ADDENDUM NO. 01

Oak Hill United School Corporation – Multi-School MEP Improvements
405 South Washington St, Swayzee, IN 46986
7760 Delphi Pike, Converse, IN 46919
600 Walnut St, Converse, IN 46919

Addendum One (AD.01) to the drawings and specifications prepared by Gibraltar Design for **Mechanical Improvements Across Three Schools** for Oak Hill United School Corporation Converse, Indiana.

1 **UNIT "B" FIRST FLOOR ELECTRICAL DEMOLITION PLAN**
ED102 1/8" = 1'-0"

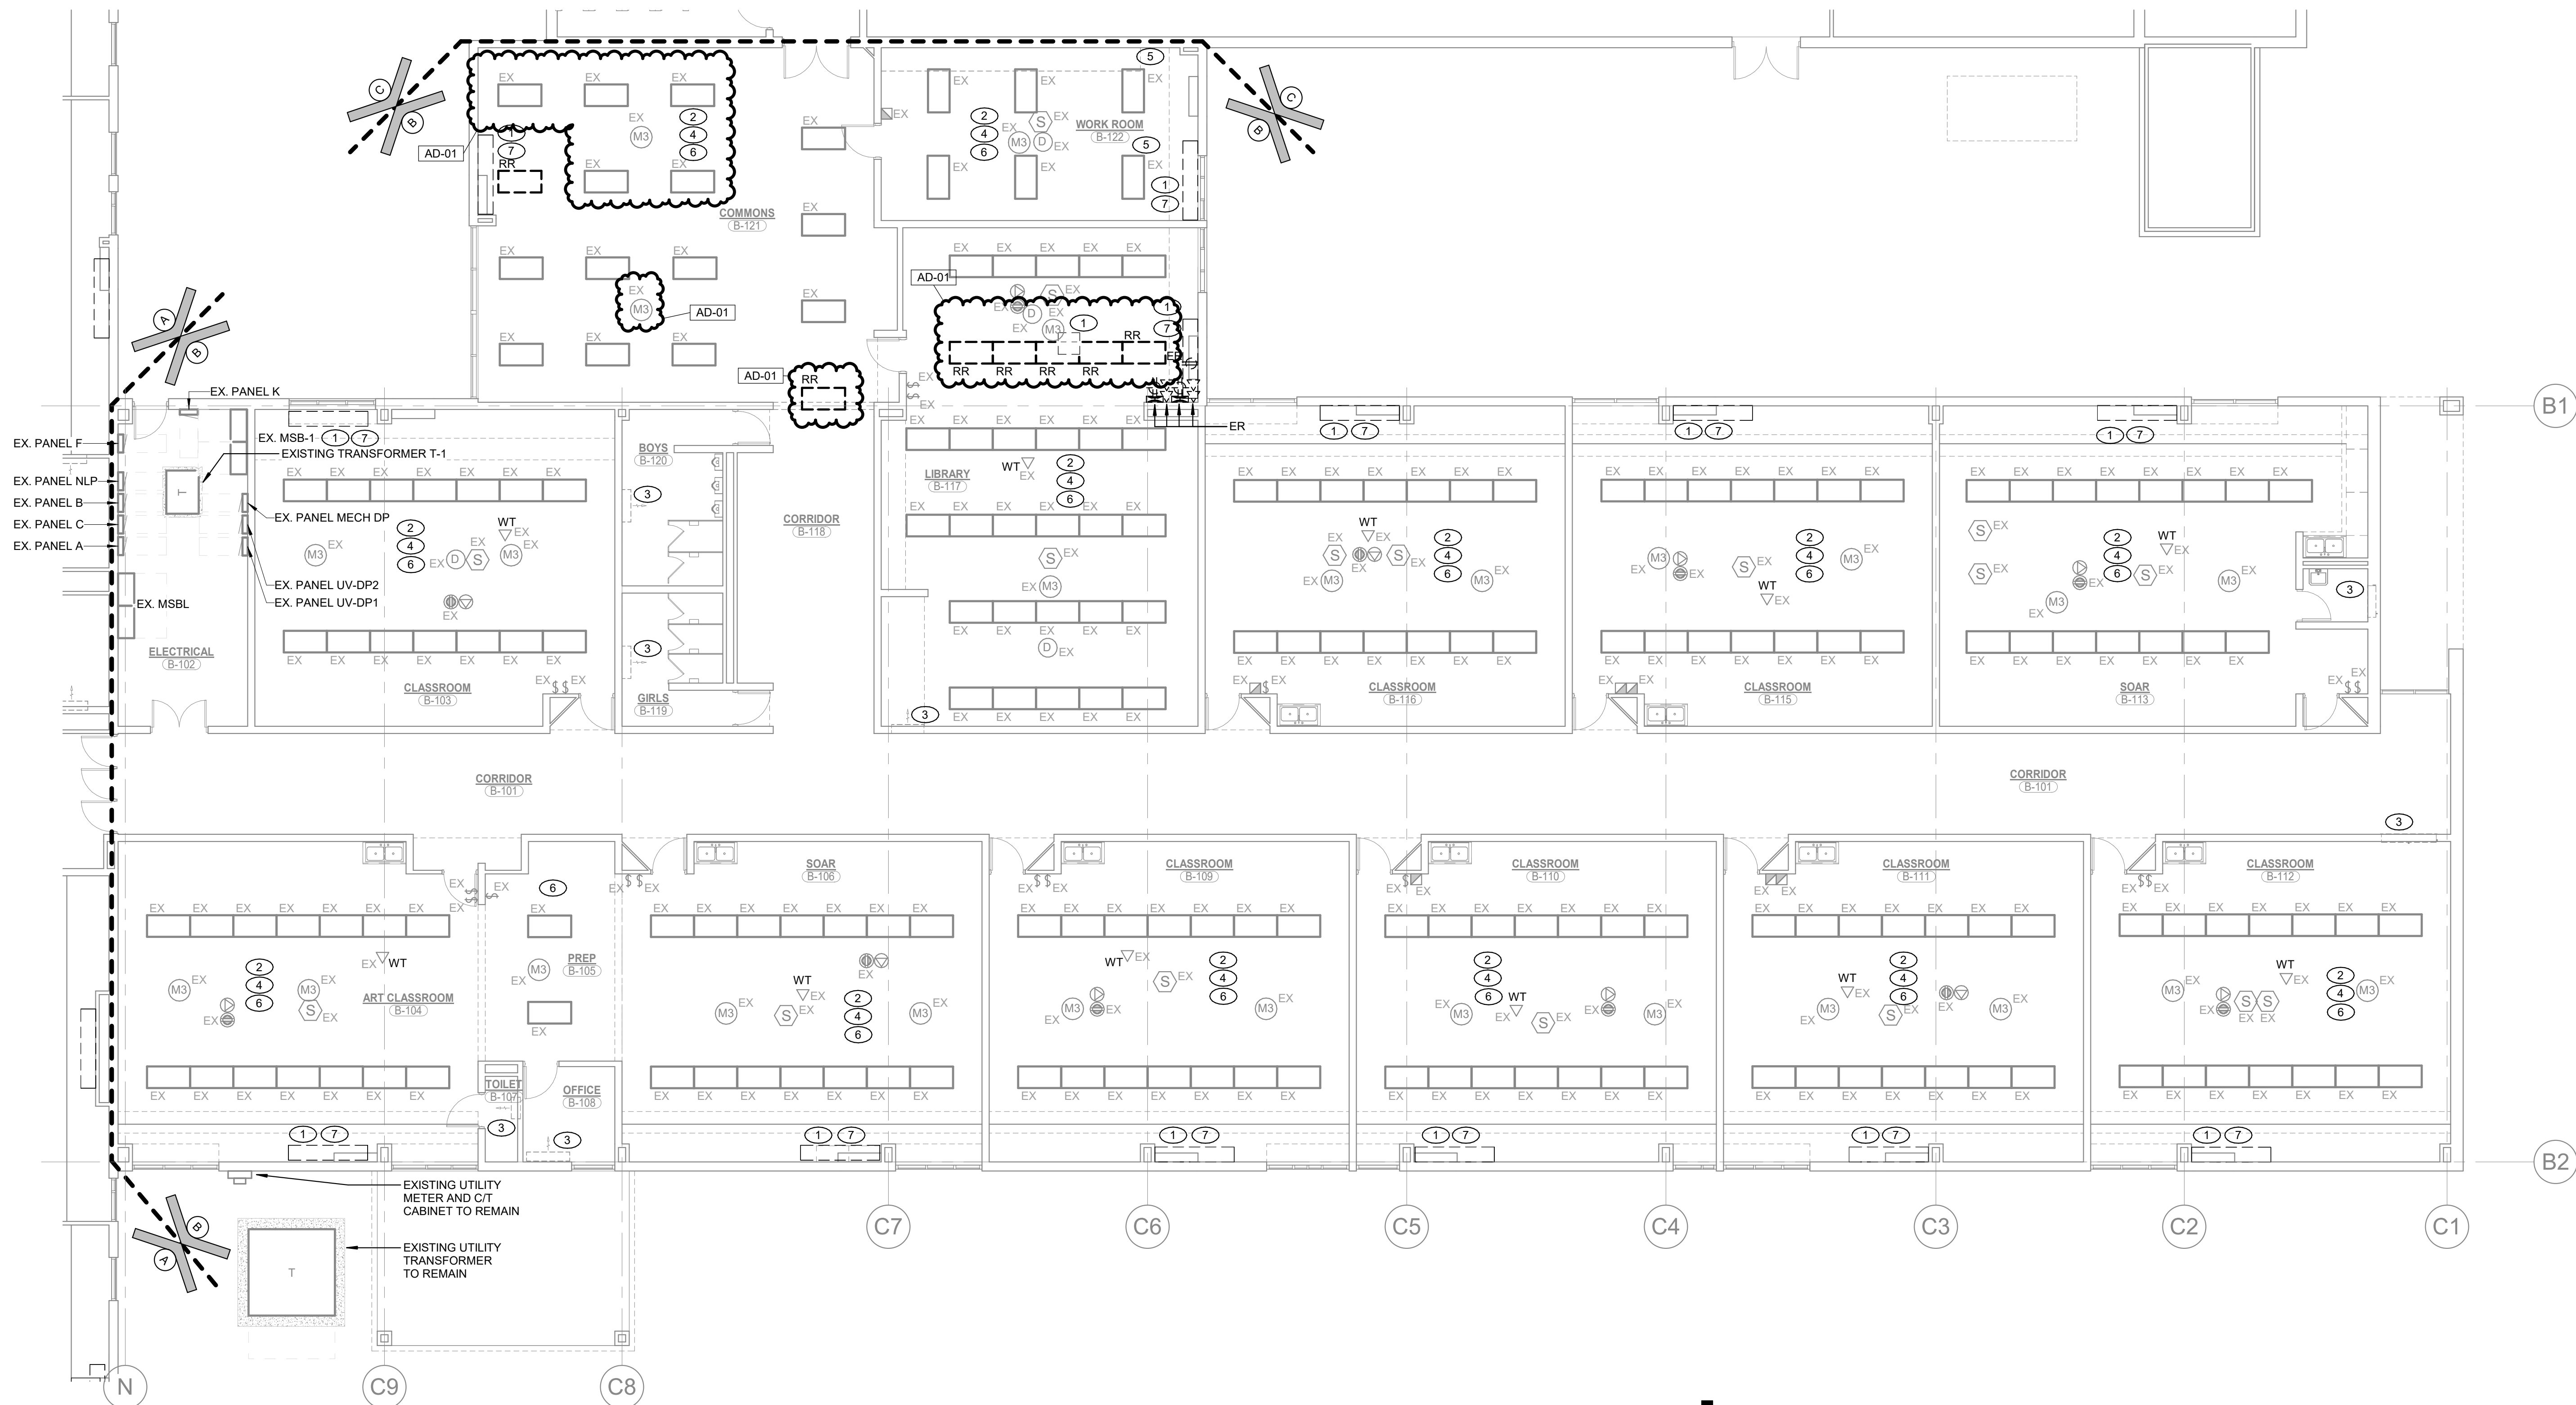
33. Sheet ED102

- A. Refer to revised, full-size drawing, included in this Addendum, for revisions.
 1. Added mechanical equipment to be removed and all associated notes.
 2. Revised lighting phasing.
 3. Added occupancy sensors.

1
EL102
UNIT "B" FIRST FLOOR ELECTRICAL LIGHTING CEILING PLAN
1/8" = 1'-0"

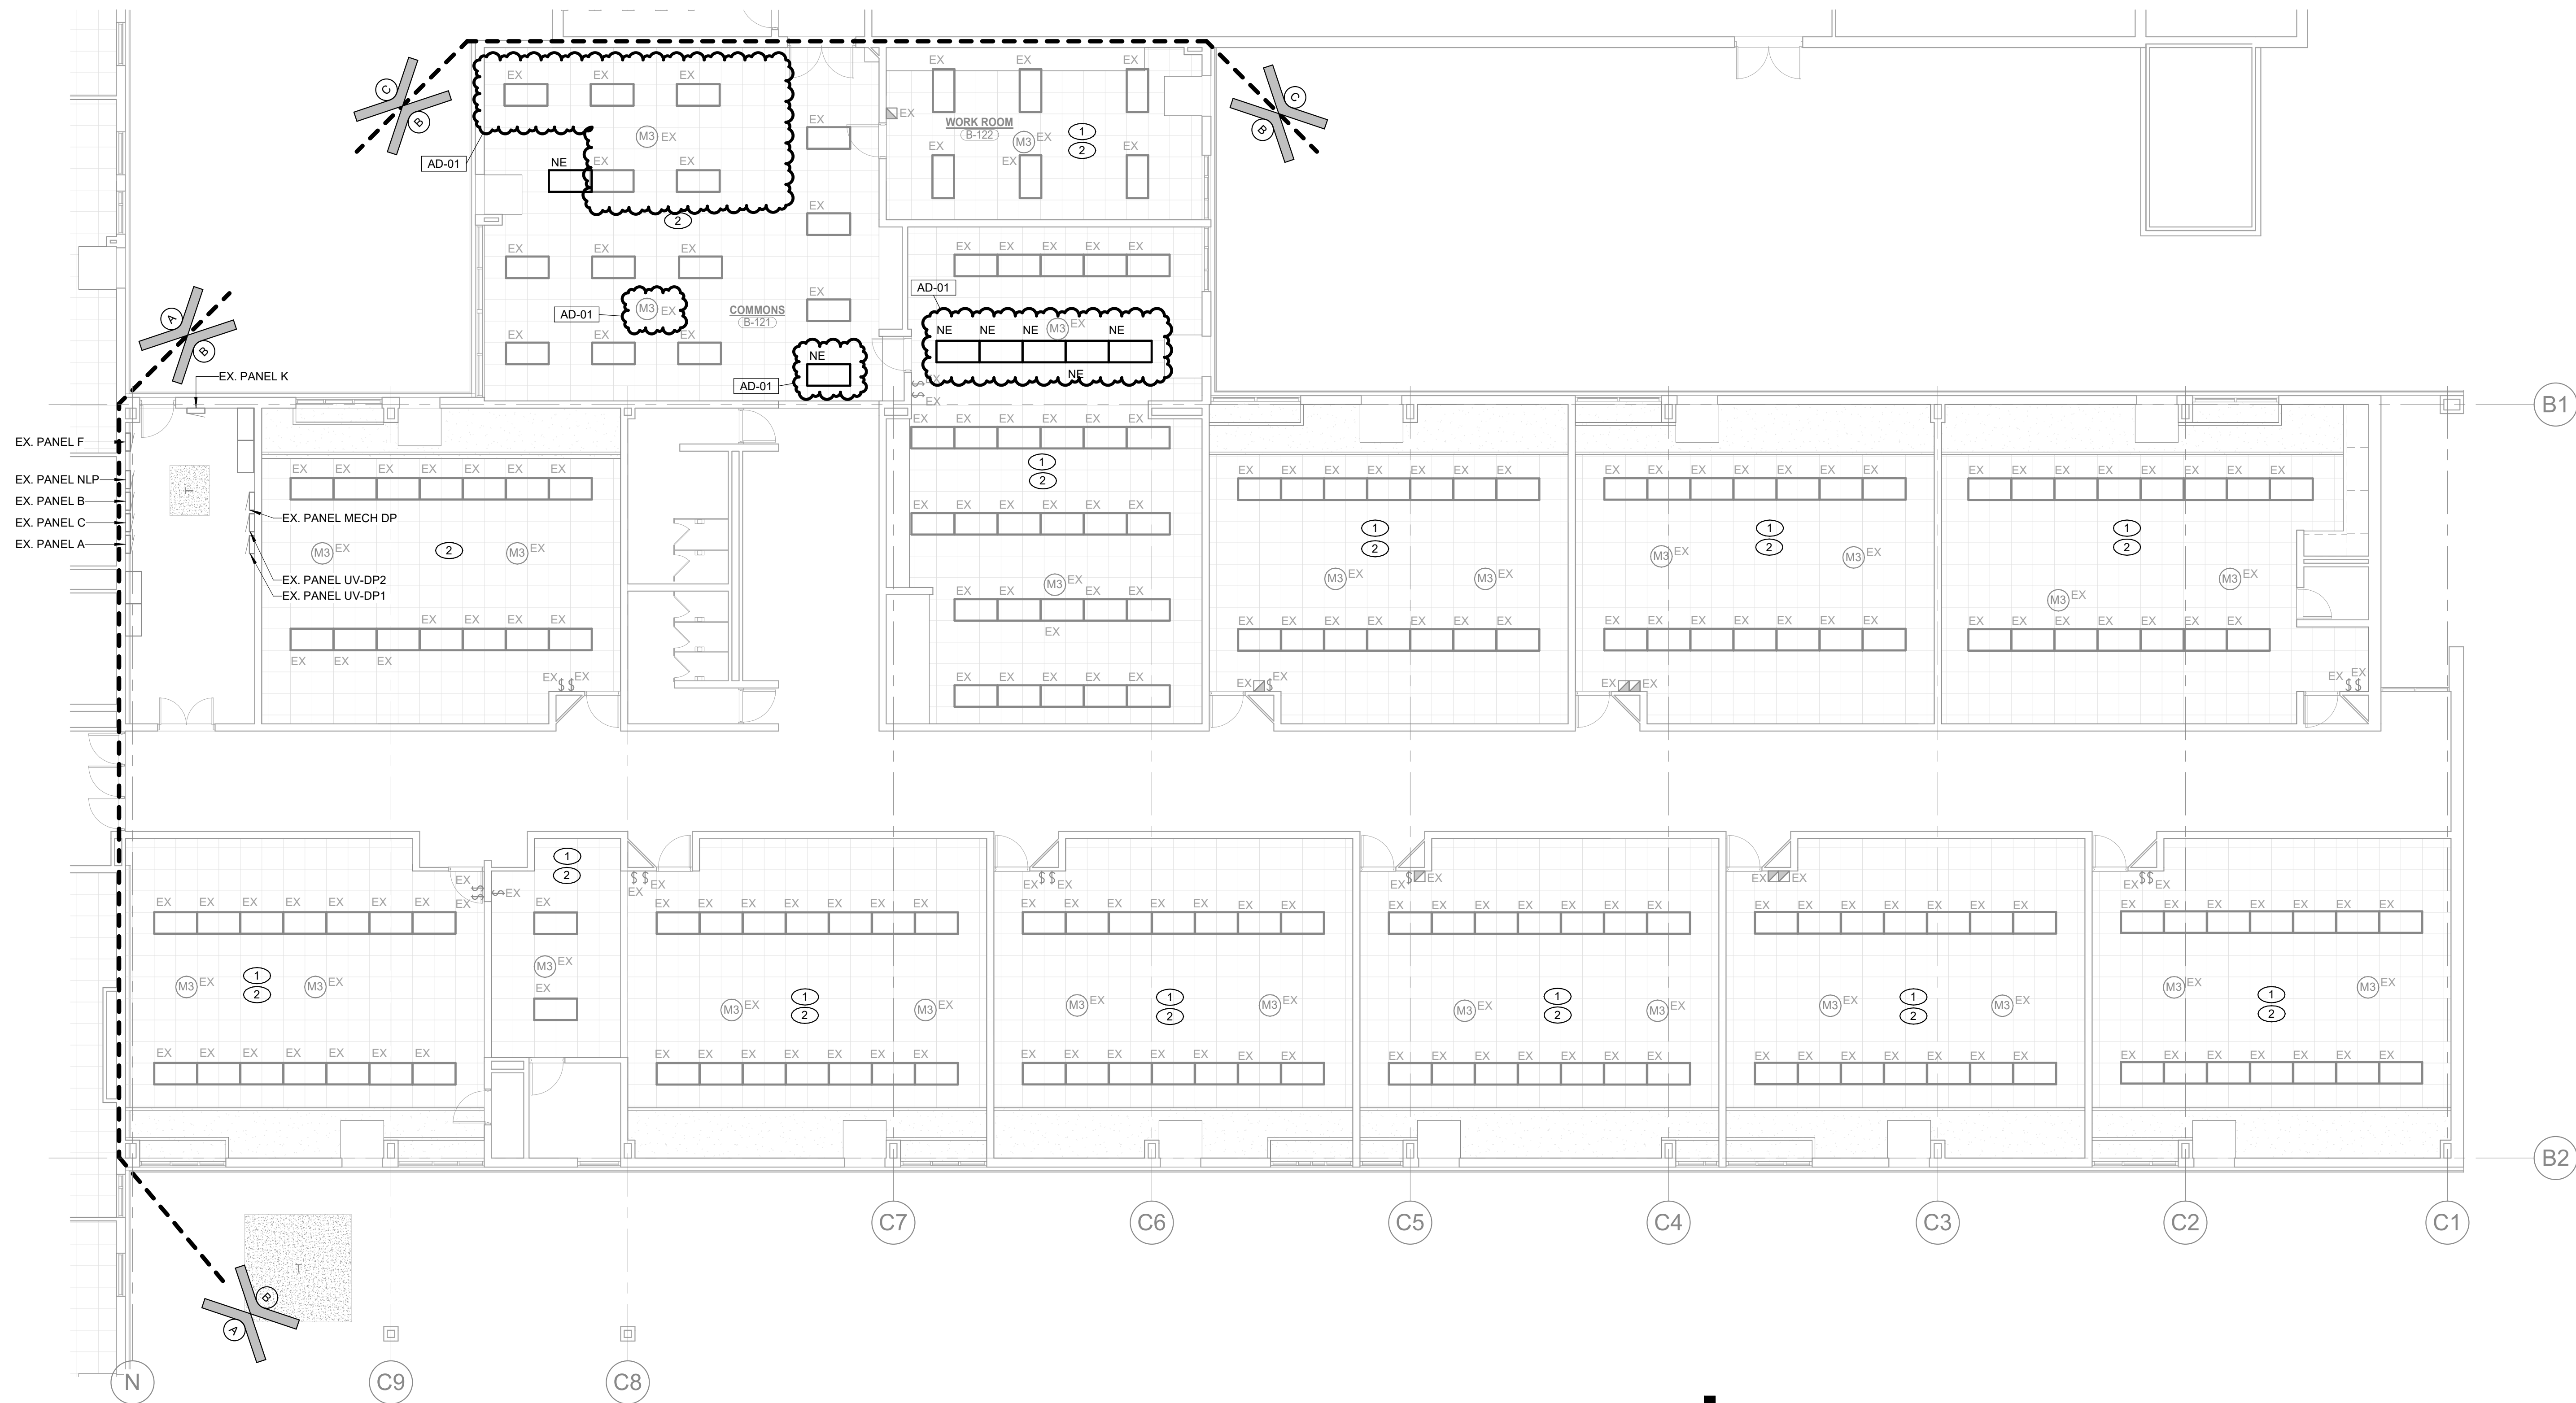
34. Sheet EL102

- A. Refer to revised, full-size drawing, included in this Addendum, for revisions.
 1. Revised lighting phasing.
 2. Added occupancy sensors.

© GIBALTAR DESIGN
SHEET
A EP101

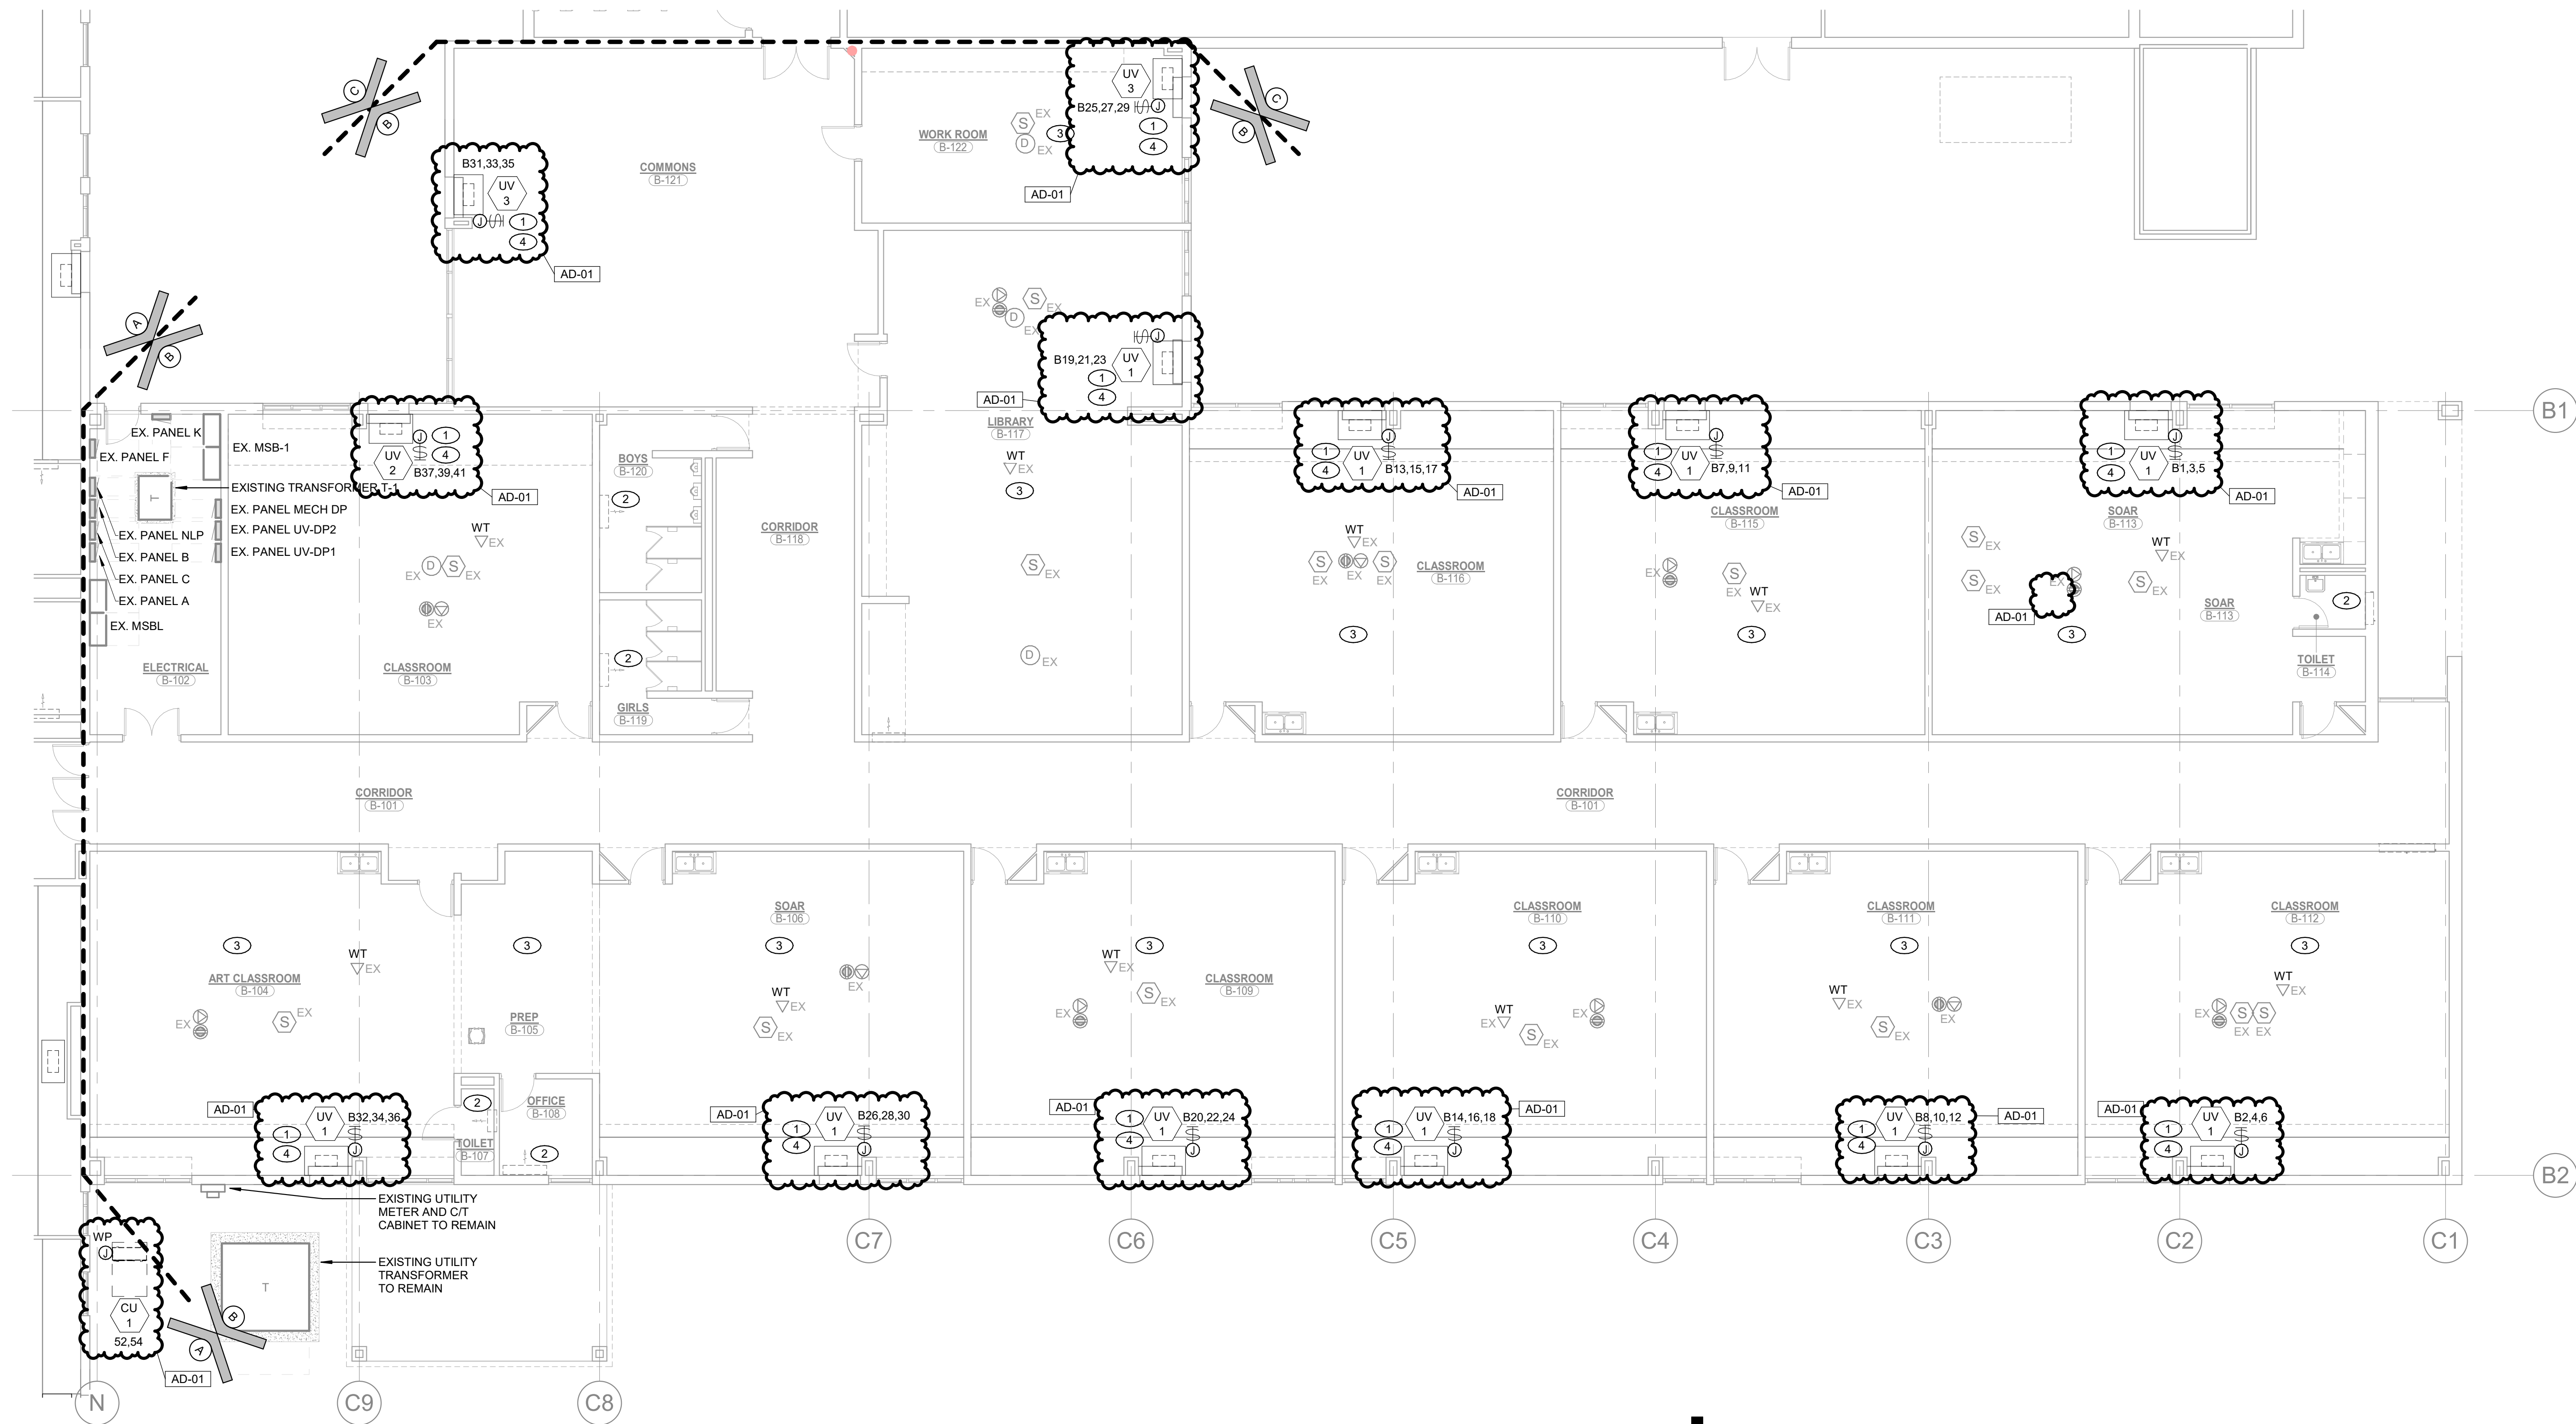
35. Sheet EP101

- A. Refer to revised, full-size drawing, included in this Addendum, for revisions.
 1. Added circuit tags to clarify what is already shown in the mechanical connection schedule.
 2. Revised general note #2.
